CITY OF SHEBOYGAN
ARCHITECTURAL REVIEW APPLICATION
Revised November 2009

Re: New Burger King Restaurant, Washington Square Sheboygan, WI.

Change to North Elevation - Drive thru side 3rd window revision

ITEM DESCRIPTION: New Burger King Restaurant on Parcel Number 431754 (Washington Square Outlot- S. Business Drive) - Resubmittal

Proposed 3rd Window/Tower

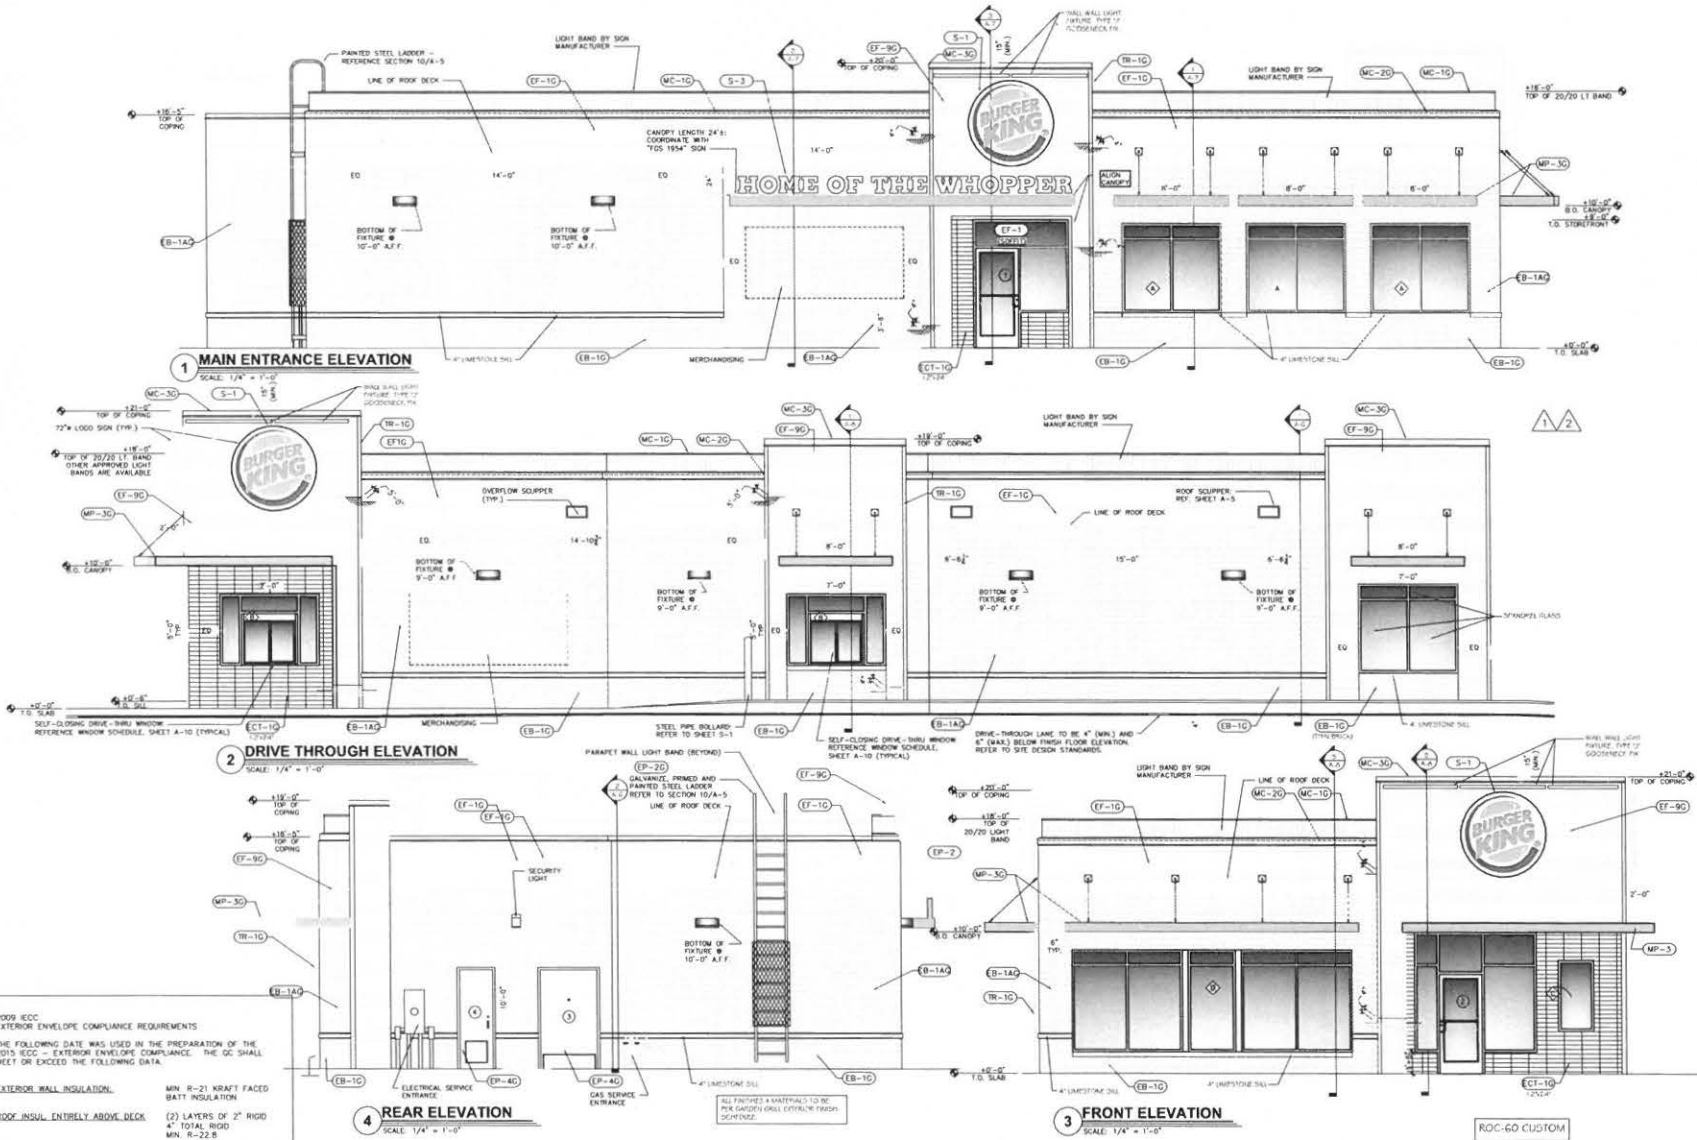
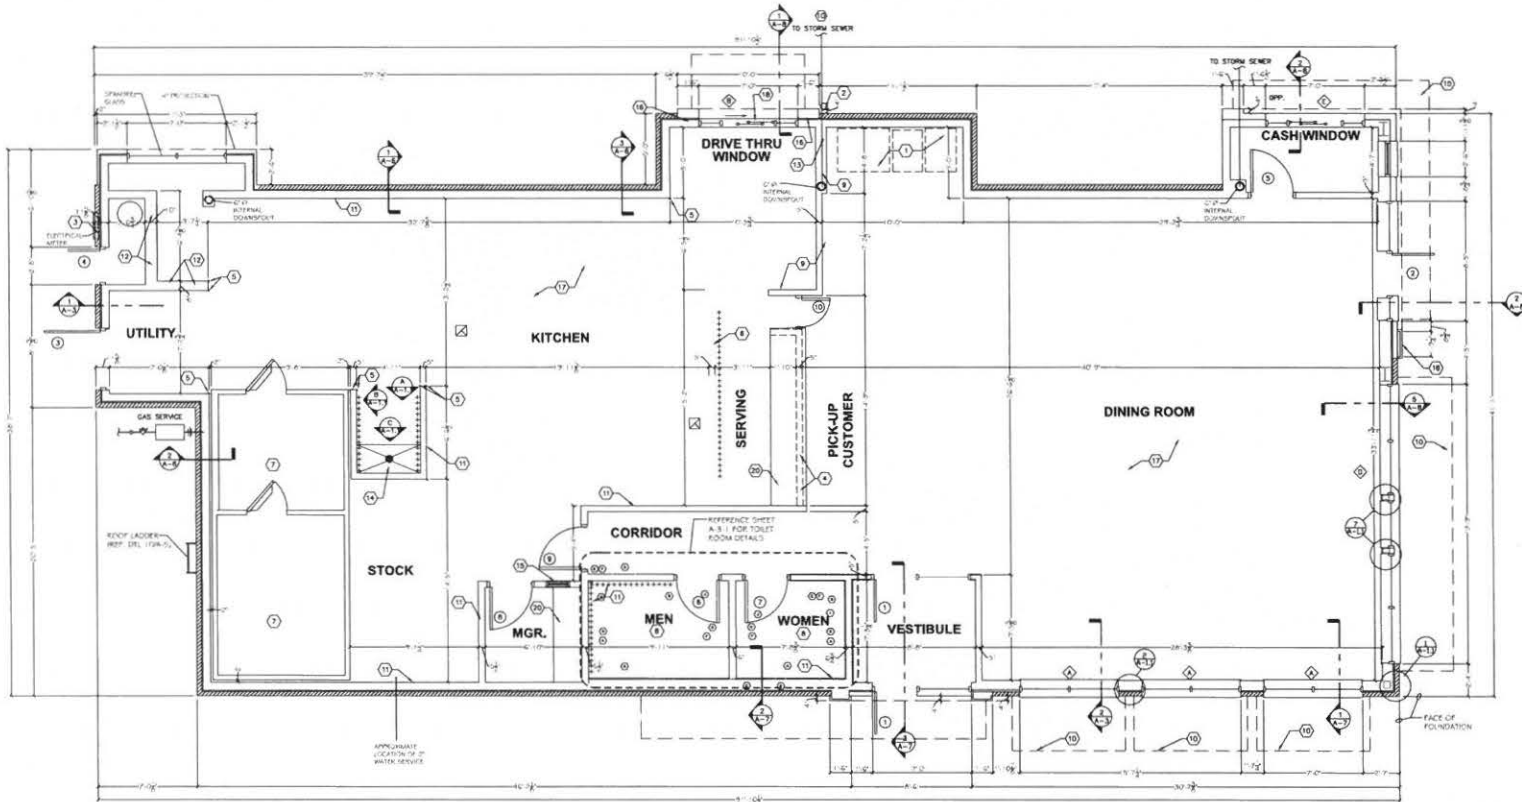
The original submittal that was presented included a 3rd Drive-thru pick up window located in the back (kitchen) area of the restaurant. The window feature included a projecting tower element incorporated into the window design that brought the window to the back of drive-thru curb in order to properly deliver food to the guests in their vehicles.

The addition of a third window is not a prototypical design element commonly used within the Burger King Brand. Most all Burger Kings operating in the U.S. use only one or two drive thru windows, a pay window and a pick up window. The 3rd window was a supplemental window that was intended for occasional use if a customer had a unique order that required additional prep time.

When the Burger King Franchisee, Cave Enterprises (CE), presented the option to the Franchisor, Burger King Corp. for operational approval the 3rd window option was operationally unapproved. The Brand has created a specific platform around enhanced drive thru execution and performance that is measured and timed specifically from point of sale at menu board order station to the pay window and the final pick up window. The platform is tied into the POS and the drive thru timer system. Incorporating a 3rd pick up window created an anomaly in the platform that the Brand could not integrate into their system.

- 3) The variations of a re-introduced tower element that they came back with did not seem well integrated with the rest of the building's architecture (much too "pasted-on"), and they were resorting to spandrel-glass. That, plus the fact that the tower/window/canopy all FELT like part of the drive-thru process (even though they were NOT) seemed confusing for customers, and just way too "fake."

- The variations of a re-introduced tower element do not seem well integrated with the rest of the building's architecture (looks pasted on) and is not as attractive as the original design.
- The fake tower/window/canopy still feels like part of the drive-thru process and seems confusing for customers.

The revised elevation eliminates the 3rd window as a functioning pick-up window while maintaining the original design intent of the additional tower element for architectural and aesthetic interest.

- One that attempts to maintain the third drive thru window tower element.

Proposed Brick

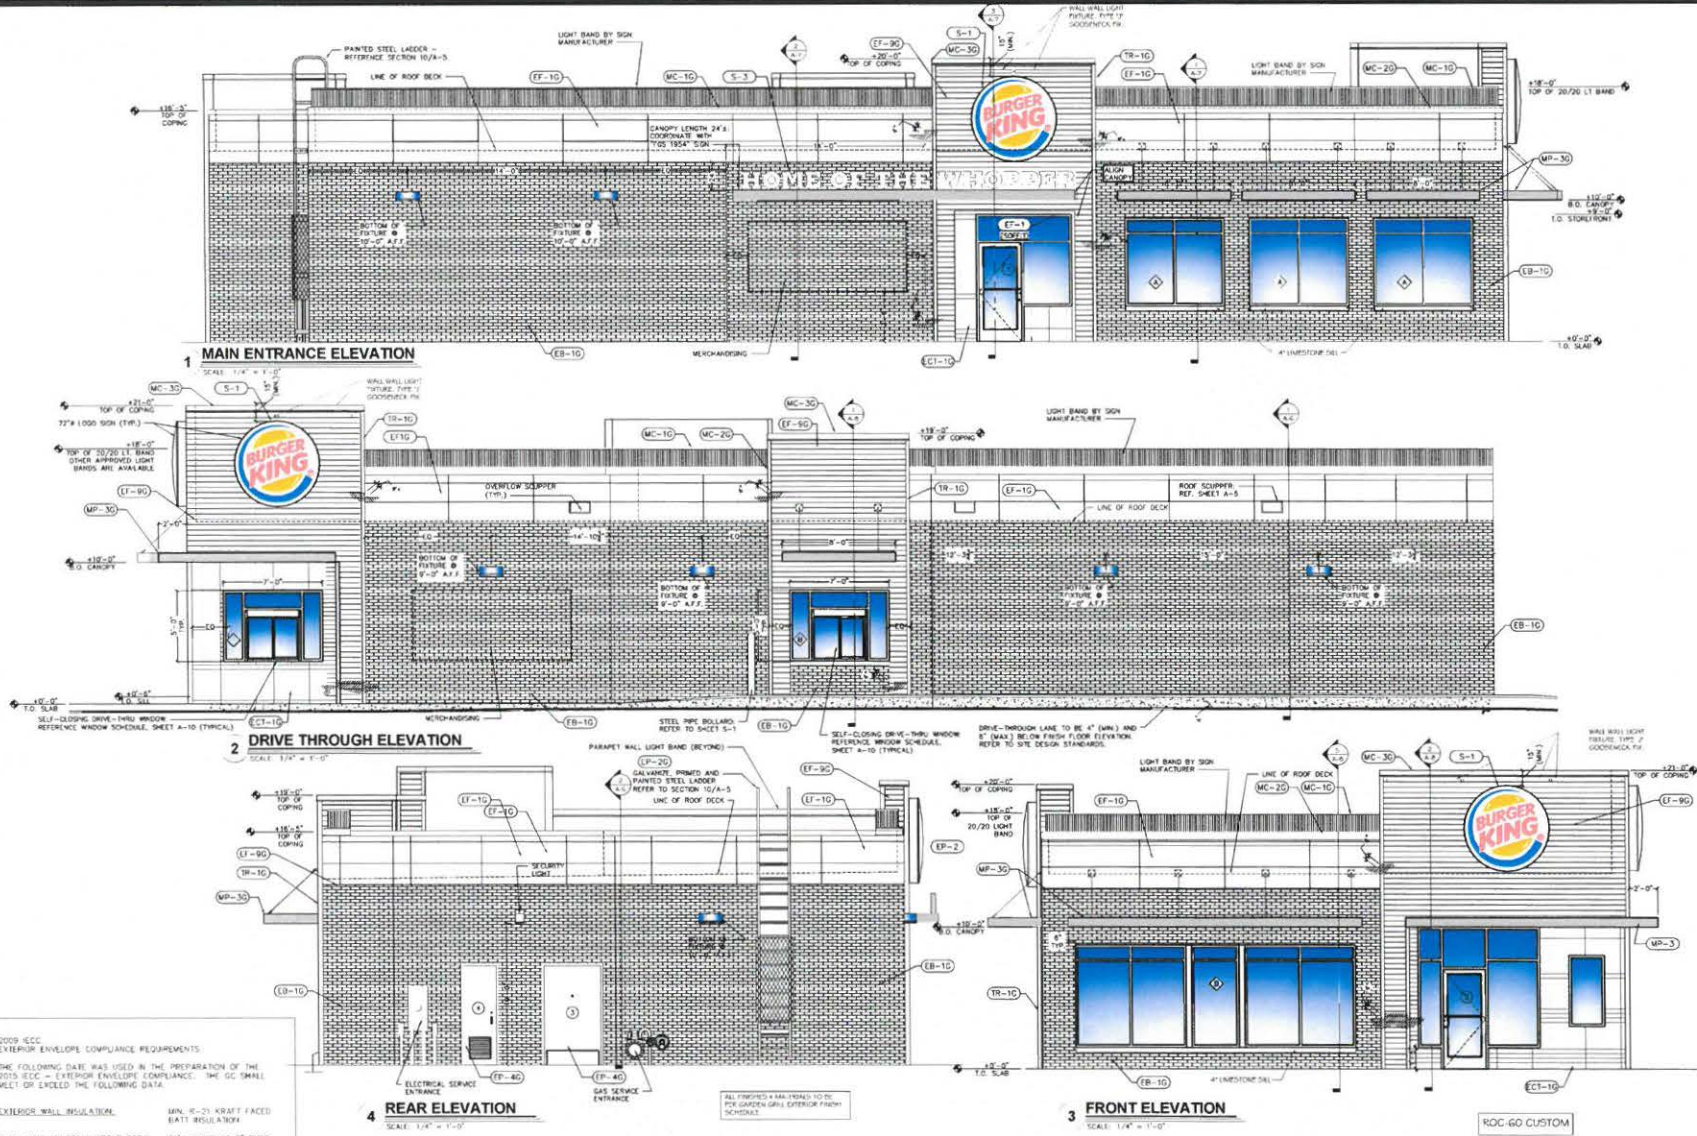
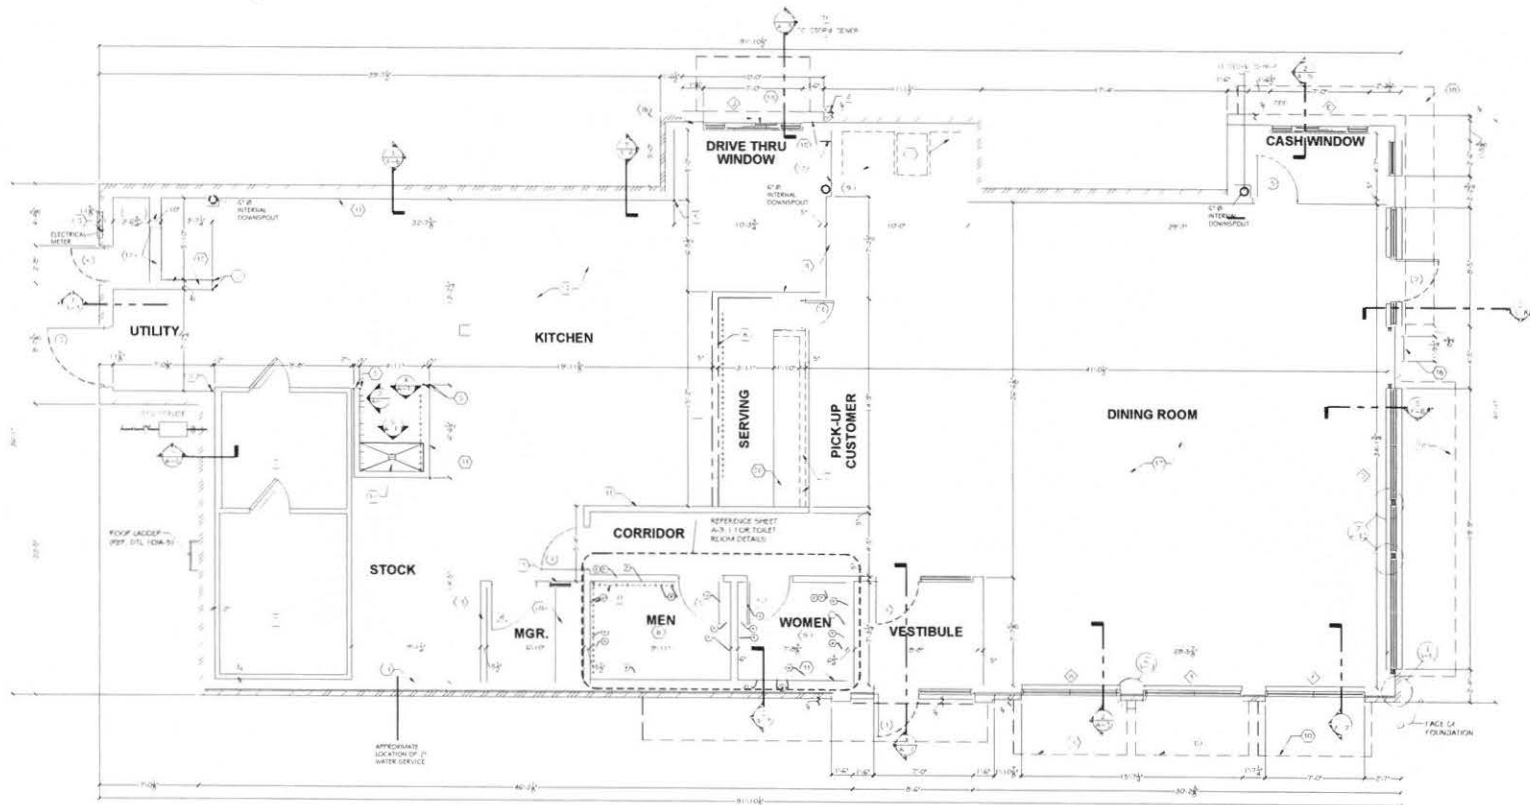
- 2) Apparently Burger King CORPORATE didn't like the third drive-thru-window option, so it had to be deleted. Steve and I then reviewed a stripped-down re-submittal that completely removed the third tower, and decided that they would either have to keep something pretty close to the original tower design or re-submit to ARB since the stripped-down version was significantly different from what we'd approved.

- 4) Given that the re-introduced attempt at a "tower element" didn't seem like a good solution when it wasn't REALLY working as a drive-thru element, my preference was for the simplified design that just eliminated the tower completely.

So – my preference was for the stripped-down design, rather than having the "fake drive-thru tower."

- One that removes the third drive thru window tower element and replaces it with brick.

If the applicant is unable to construct the original proposal, staff would recommend approving the drawing that replaces the third drive thru window tower element with brick because:
